19 January 2022
Selwyn District Council
CHRISTCHURCH

Request for Further Information: Plan Change 82

Thank you for your Request for Further Information dated 13 December 2021. WE have responded to your questions and comments below. I have noted when a response has been provided by a technical expert, for clarity.

Figure 1: Odour Constrained Area and WWTP Setbacks

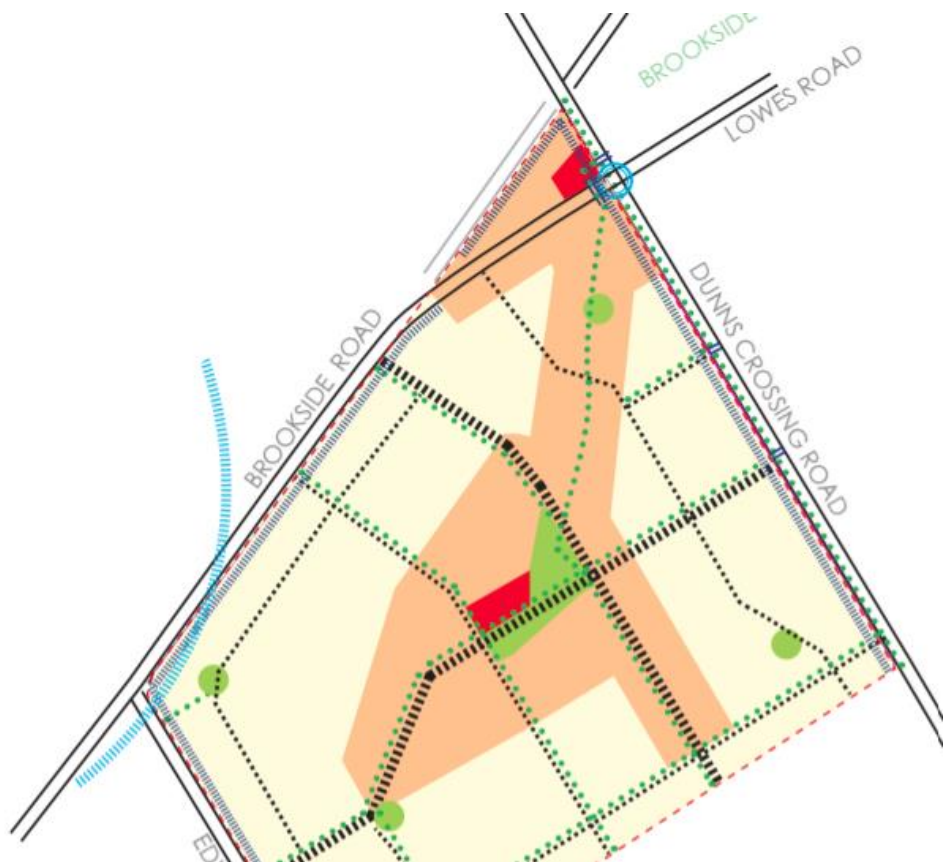
5. Through the hearing process for PC73, proposed provisions were proffered for inclusion within the District Plan that precluded the development of residential allotments within 1500m of the Pines Wastewater Treatment Plant buildings prior to certification by Council's Asset Manager that the resource management approvals required to enable the Plant to provide treatment capacity for 120,000 person equivalents of incoming flow have been obtained or 31 December 2025, whichever is the sooner. Please advise if this measure is also proposed to be adopted in relation to this plan change. If so, please provide a map indicating the extent of the plan change area affected by this measure and identify this within either the ODP (either on the plan or accompanying text) or as a specific provision within the District Plan.

No residential allotments may be created within 1500m of the Pines Wastewater Treatment Plant buildings (as depicted by the line shown in Figure 1 below) prior to: Certification by Council's Asset manager that the resource management approvals required to enable the Pines Wastewater Treatment Plant to provide treatment capacity for 120,000 person equivalents of incoming flow have been obtained; or 31 December 2025, whichever is the sooner.

Figure 1: Indicative Sketch of Turning Head and Closure of Brookside Road west at Dunns Crossing Road

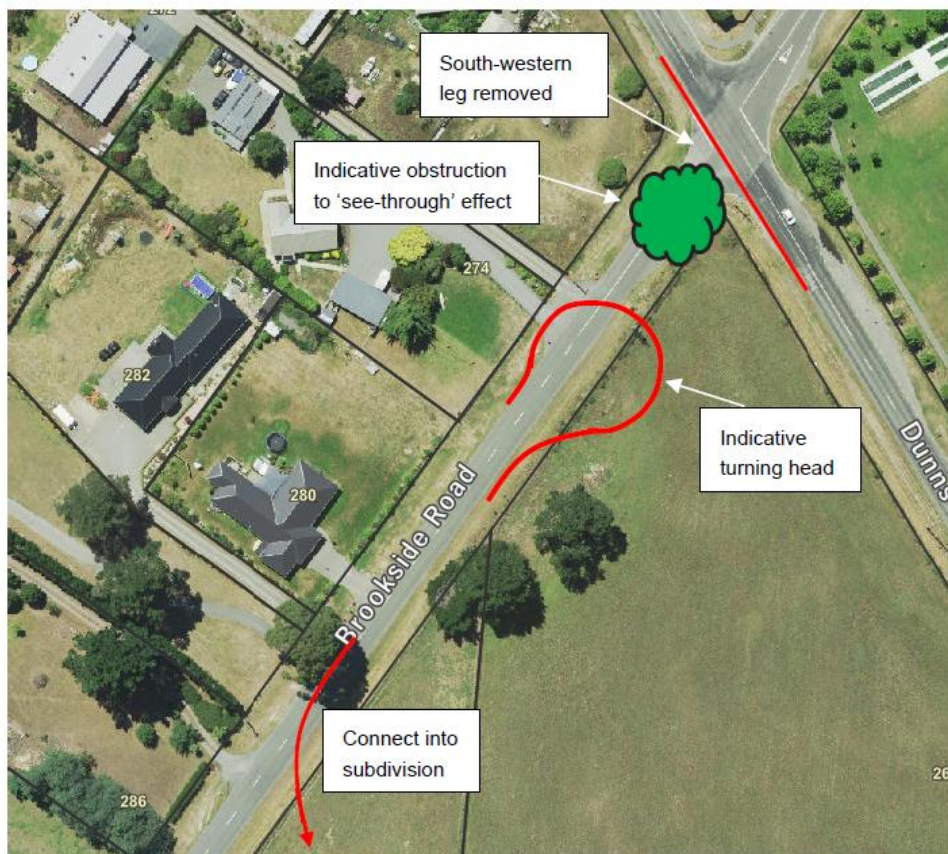
20. Please provide an assessment of the Dunns Crossing Road/Brookside Road (east) intersection, including any interaction (e.g. queuing effects) between this intersection and the proposed Dunns Crossing Road/Lowes Road roundabout. Please also consider and clarify how existing property access on the northern side would be provided. It is noted in the Urban Design Statement that the termination of part of Brookside Road would allow the existing small enclave to the north to be directly connected to the residential development within the plan change area. As the proposed realignment will have a direct impact on land owners in the vicinity, it is not considered appropriate that this be considered at subdivision stage, as suggested in Section 8.3.2 of the ITA, where opportunity for engagement by and with these property owners is not provided for.

The northern Dunns Crossing Road approach to Lowes Road roundabout is forecast to operate well, with LOS A in both the AM and PM peak in the latest modelled scenario. There will be approximately 100m between the two intersections in question and therefore the queue north of the Lowes Road roundabout would not be expected to interact with the Brookside Road intersection. The design of the Brookside Road T-intersection should consider whether a right turn bay would be warranted at the intersection to minimise impacts on through traffic.

It will be best for the safety and efficiency of the Dunns Crossing Road / Brookside Road intersection if the south-western leg is severed at the intersection, as indicated below. Some form of vertical obstruction to stop the 'see-through' effect would likely be warranted opposite the intersection. The existing section of road to the south-west which serves 5-6 properties could be stopped at the last driveway, possibly with a turning head as indicated below. The design of this would be considered further at the subdivision stage. It is considered that where and how exactly the cul-de-sac joins the realigned Brookside Road could also be considered at the subdivision stage. The affected residents could be informed that their properties will be served by a low volume local road and they will have safe and convenient access to Dunns Crossing Road via a new roundabout at the Lowes Road intersection.

Figure 3: Concept for Lowes Road / Dunns Crossing Road Demonstrating Feasibility

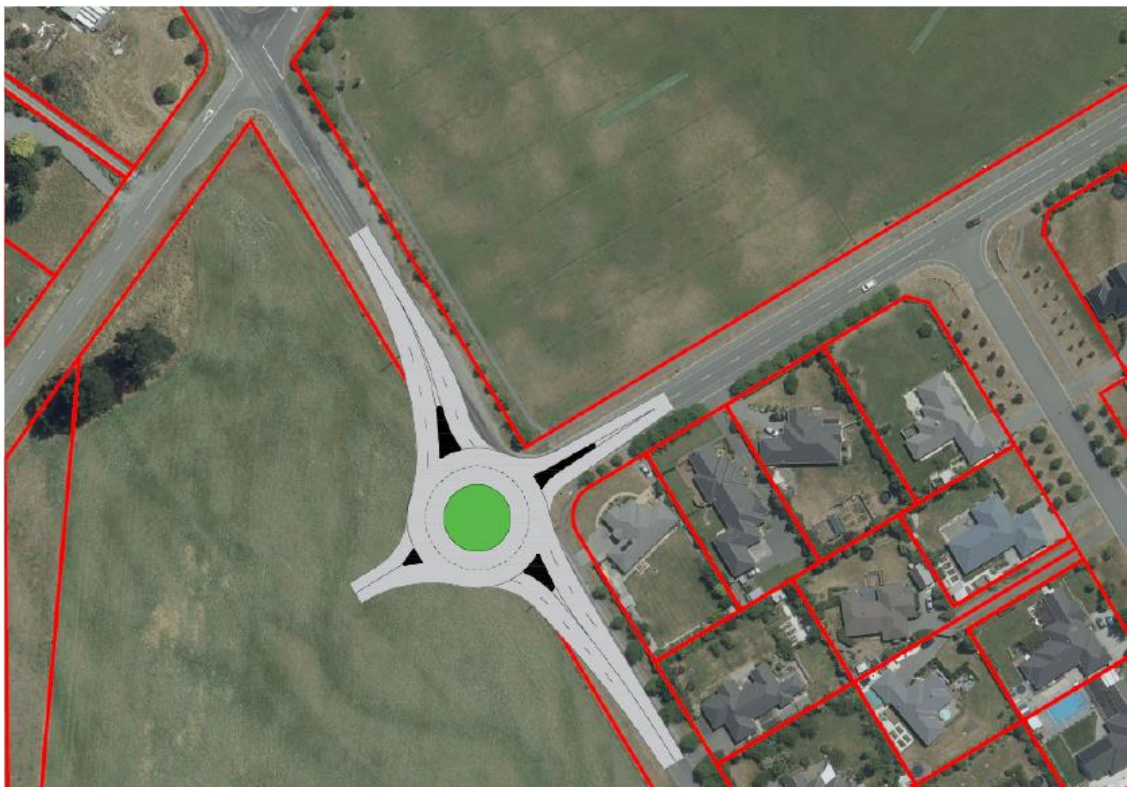
23. Please comment on whether a concept design for the Dunns Crossing Road/Lowes Road/Brookside Road intersection has been developed which reflects the assumed form adopted in the SIDRA model, and whether the OPD should identify the need to allow for land protection/vesting to enable this intersection to be formed.

The latest simulation modelling carried out with PC80 and PC81 included indicates that dual through lanes may be required on Dunns Crossing Road at some stage if a good level of service for vehicles is desired representative of the arterial intersection classification. A left turn lane was also included on the western leg.

The following concept sketch shows an indicative roundabout centred to the south-west of Dunns Crossing Road so that it does not impact existing property boundaries owned by third parties. A 20m diameter island has been adopted based on Austroads standards for a dual-lane, arterial road roundabout although that could be reviewed based on the type of heavy vehicles that would use it. Lane configurations would be determined based on detailed assessments at the time of intersection design, and the modelled left turn lane from the west could readily be included as required. The intersection control type would also be subject to road controlling authority investigation noting the roundabout was adopted as the intersection control because it was included in the supplied model, whereas traffic signals could be feasible.

It will be a requirement at the subdivision stage that the proposed boundaries allow for the future intersection form and a refined concept roundabout design will need to be produced at this stage to ensure design requirements such as entry path radii, driver and pedestrian sightlines etc. are achievable. It may be that land requirements for the larger roundabout are protected at the subdivision stage but a smaller roundabout could be constructed initially.

Figure 1 Extent of Selwyn District Council Designations (outlined and hatched in red)

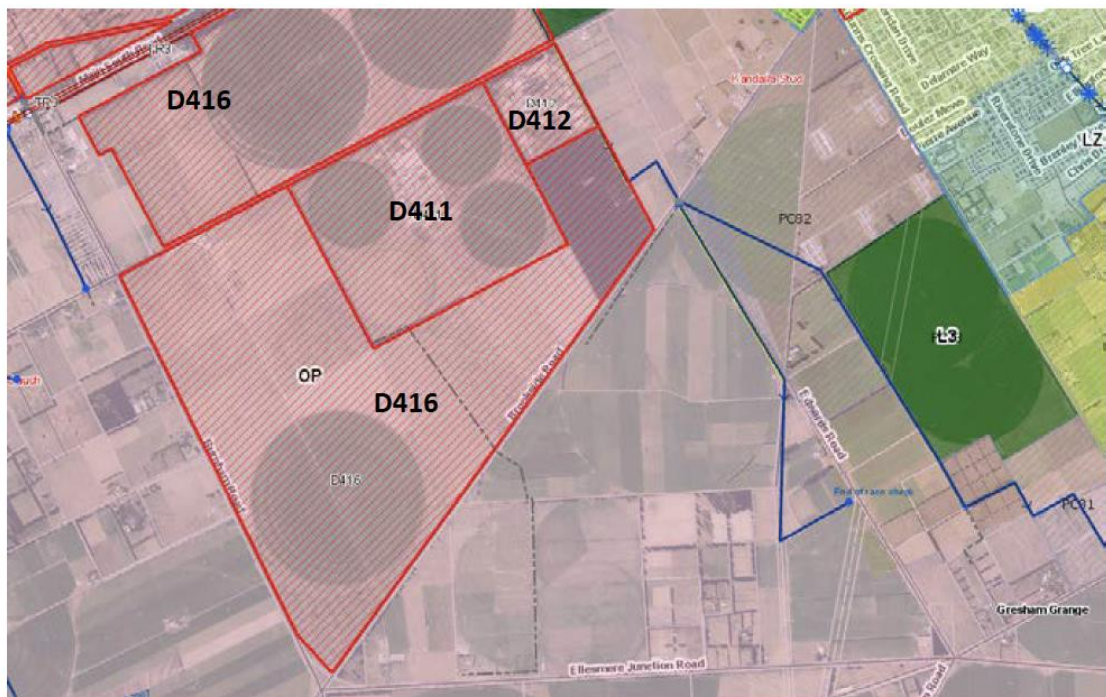
34. Figure c on page 5 does not accurately reflect the full extent of the designations associated with the Pines Wastewater Treatment Plant. Designation D416 extends south of the area shown down to Brookside Road, as per the figure below. Please acknowledge the full extent of the various designations associated with both the Pines Wastewater Treatment Plan and Resource Recovery Park and advise if the proximity of the designations, being some 180m from the edge of the plan change area has an impact on the site of the plan change request.

Figure C on page 5 is a graphic error and will be corrected to include the area D416 all the way to Brookside Road.

The correction to the Fig c therefore does not affect the assessment of the impact of the designations on PC82.

The proximity of the designations, approx. 180m from the edge of the plan change area has no discernible impact on the site of the plan change request.

Figure 6.12: Proposed Rolleston Structure Plan Diagram

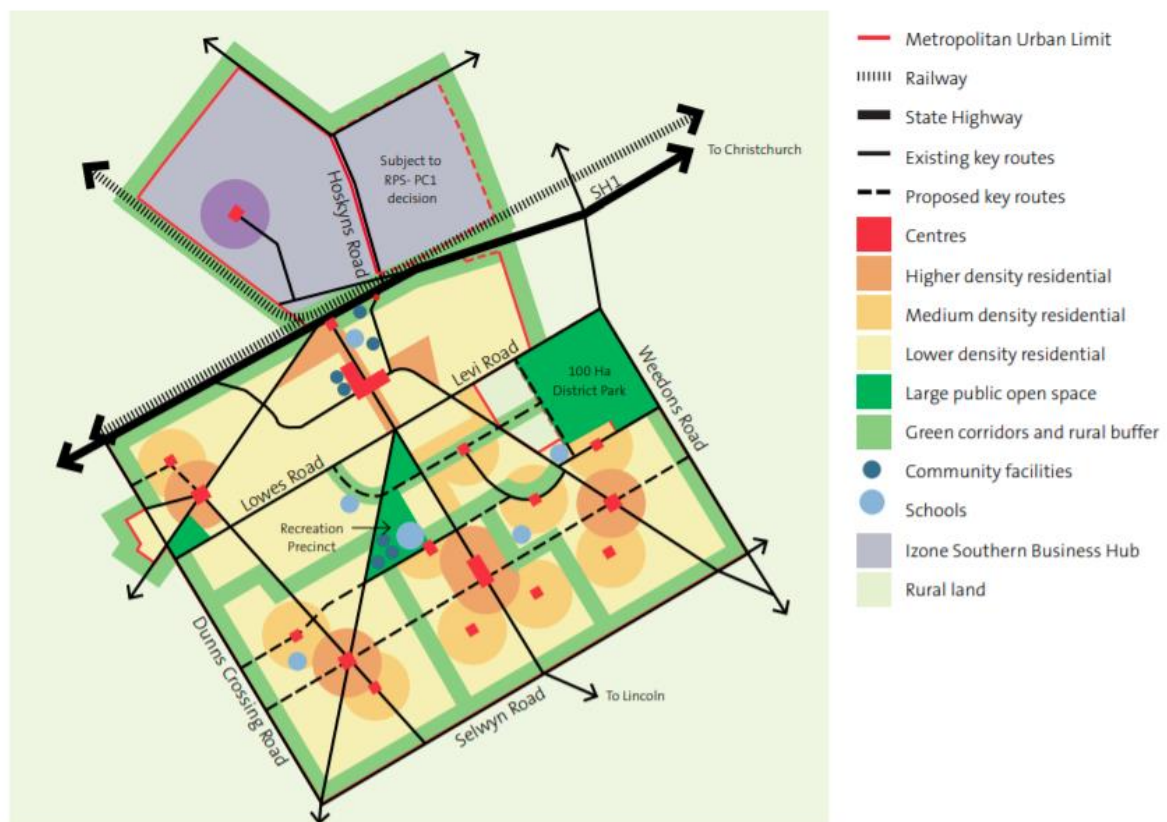
35. The figure on page 13 appears to indicate that the scale of the Business 1 zones proposed within the plan change area are of a lesser scale than the Business 1 zones proposed by and within PC73. Similarly, the following commentary, from page 12, expresses that “the commercial activities proposed by PC 73 would provide alternative local commercial centres in closer proximity [to the town centre]. The Holmes block commercial area would be located 700m from the northern corner of the Site and the Skellerup Block local commercial area would be approx. 800m away from the south-west corner of the Site. Both areas would be within a 10min walking distance.” This commentary appears to consider that the commercial areas proposed within PC73 would be such that they could be at a greater scale than that proposed within this plan change area. However, PC73 seeks to provide the same zoning as proposed by this request, namely Business 1 (Local Centre). Please clarify the nature and scale of the Business 1 zone proposed by this request and amend as appropriate.

The urban design statement mentions the other two local commercial areas to show how the proposed local centres integrate into the distribution of commercial centres in the western part of Rolleston
